80296SA MICROCONTROLLER SPECIFICATION UPDATE

Release Date: February, 1997

Order Number: 272908-006

The 80296SA may contain design defects or errors known as errata. Characterized errata that may cause the 80296SA's behavior to deviate from published specifications are documented in this specification update.

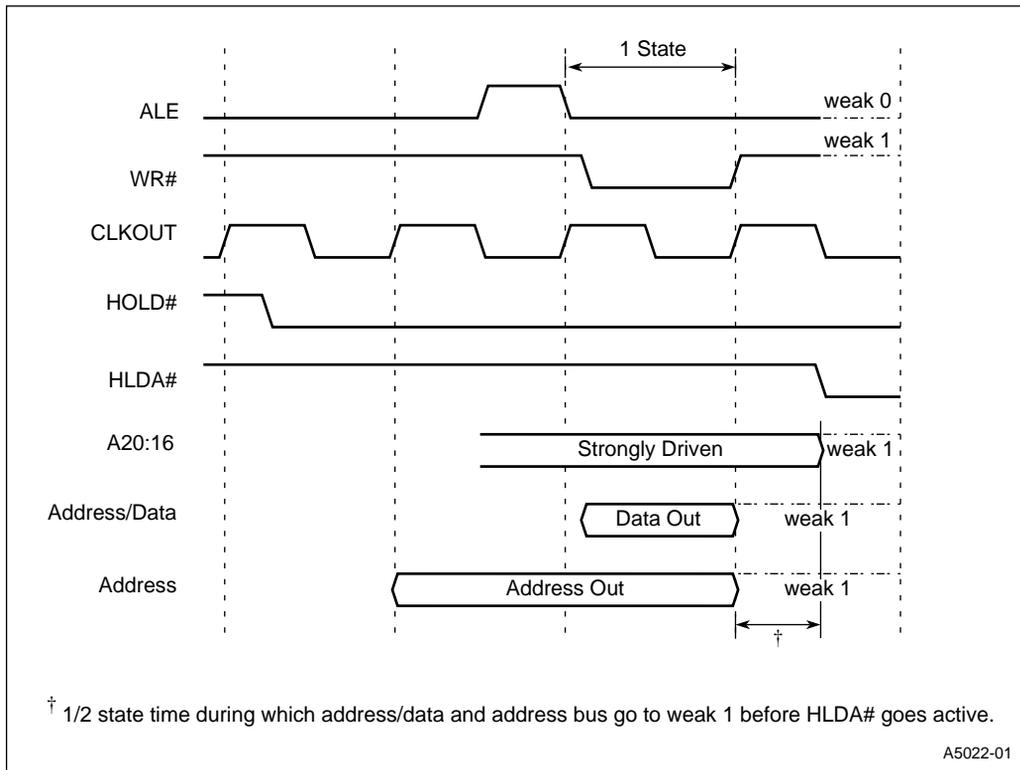
PROBLEM: The pin status table in the *80296SA Microcontroller User's Manual* states that the address bus, EPORT, and address/data bus should be high-impedance during hold, but these pins are weakly held high instead.

IMPLICATION: Potential bus contention could occur if the device driving the bus is not strong enough to drive the weakly held high signals to the desired state.

WORKAROUND: Do not use hold or ensure that the device driving the bus can overcome the weak driver.

Behavior of Bus Signals When Entering Bus Hold

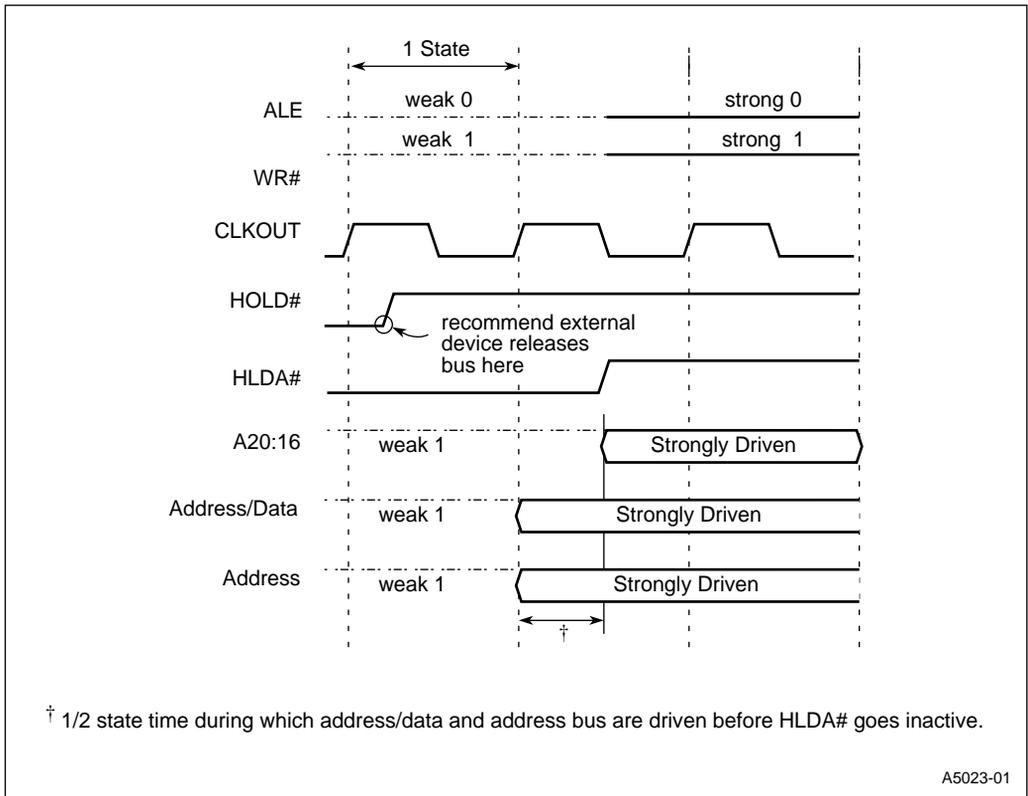
PROBLEM: When going into bus hold, the address/data bus and address bus pins go to their hold values about 1/2 state early before HLDA# goes low. The other bus signals, such as the EPORT, ALE, RD#, WR#, etc., remain strongly driven for about 1/2 state longer until HLDA# goes active. Please refer to the diagram:

IMPLICATION: In the figure above, a write cycle is occurring just before the 80296SA releases the bus and goes into hold mode. This write cycle cannot be relied upon, since the 80296SA stops driving valid information on the address and address/data bus at nearly the same time as WR# goes high. The address behaves the same as in normal bus cycles. The data is held longer, though, in the normal bus cycle.

This may make bus hold unreliable and unusable.

WORKAROUND: There is no workaround unless the device receiving data does not expect the data to be held after rising edge of WR#.

Example READY Timings at 50 MHz, Multiplexed Bus, BUSCONx = 1 Wait State

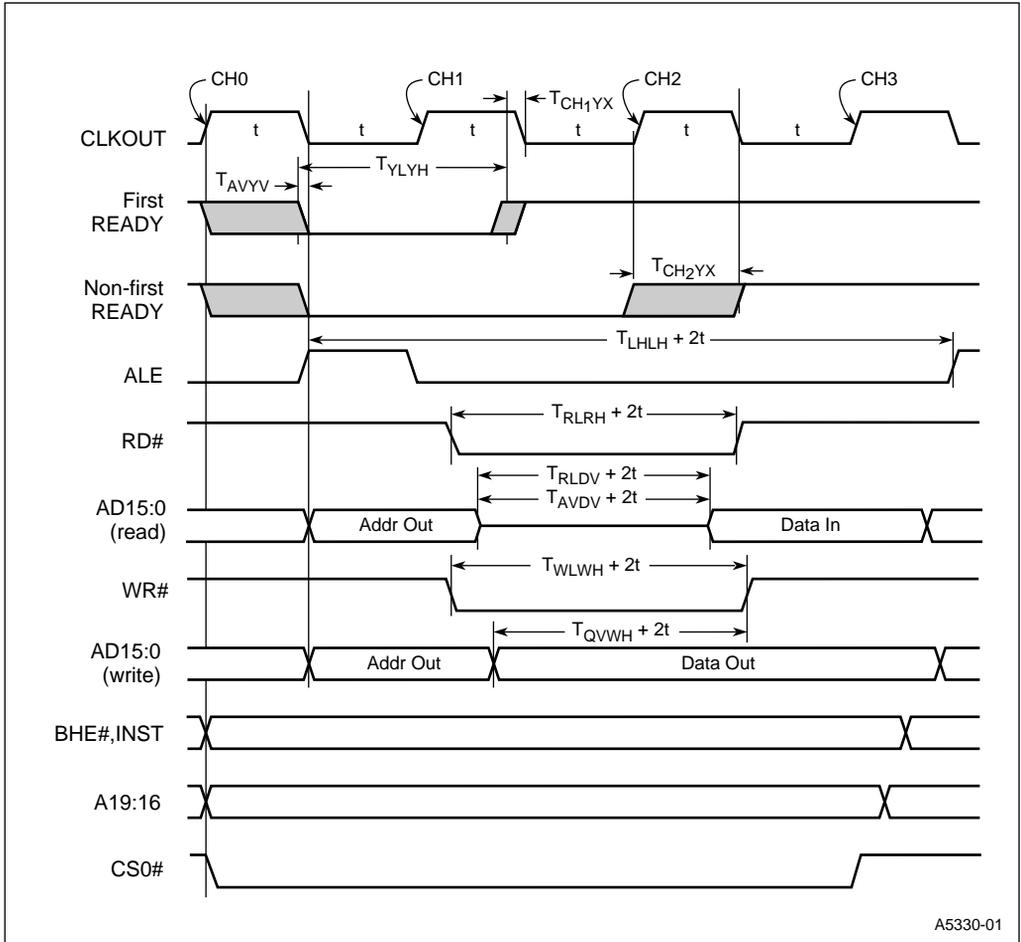
022. Replace T_{CHYX} specification with T_{CH1YX} and T_{CH2YX} for both multiplexed and demultiplexed modes; replace READY timing diagrams (Datasheet)

ITEM: The T_{CHYX} specification has been replaced by two specifications, T_{CH1YX} and T_{CH2YX} , to more clearly define the timing requirements for the first READY pulse and for subsequent READY pulses.

The following AC characteristics tables and READY timing diagrams will be included in the next revision of the datasheet.

1. If using the READY signal to insert wait states, you must program at least one wait state in the BUSCONx register because the first falling edge of READY is not synchronized with a CLKOUT edge.
2. If using the BUSCONx register **without** the READY signal to insert wait states, add $2t \times n$, where n = number of wait states.
3. If using the BUSCONx register to insert wait states, add $2t \times (n-1)$, where n = number of wait states.
4. Exceeding the maximum specification causes additional wait states.
5. If you program two or more wait states in the BUSCONx register, the T_{CH1YX} minimum does not apply.
